SERVICE BULLETIN

MODEL NAME : Di620
MODEL CODE : 1155
NO. : 017
DATE : 981119
SUBJECT : SOFTWARE PROGRAM OF IC70B ON PWB-B CHANGE

IC70B Version: 10G032-00 ➡ 10G037-00

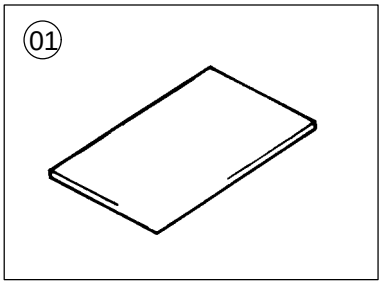
The software program of IC70B on P.W. Board-B has been changed and the following problems have been solved. Due to this, the memory program of the memory card (01) has been changed.

1. After all pages of the document are scanned in Separate Scan mode, if copying is done in interrupt mode, the copies may be blank after the interrupt mode is reset.

2. After copying is done in Cover mode with Corner Staple or 2-Point Staple selected, even though the copying is done in Memory Recall mode without a mode change, Staple mode may be reset and changed to Non-Sort mode.

3. In X/Y Zoom mode using a book original, the image may be turned and a void image may appear on the copy.
4. After the time/day card is inserted in the slot of the Data Controller D-102, the time and day may not be set.

5. In the machine equipped with the controller Pi6000:
   1) C1160 may appear on the touch panel erroneously during copying.
   2) C1270 may appear on the touch panel erroneously in OHP Interleaving mode.

3) C11F9 may appear on the touch panel erroneously in Cover mode when 2-Point Staple or Folding-Crease mode is selected.
   4) In Manual Bypass Copying, the “Exclusive paper” key may not be indicated on the touch panel or the “Exclusive paper” key may not operate.
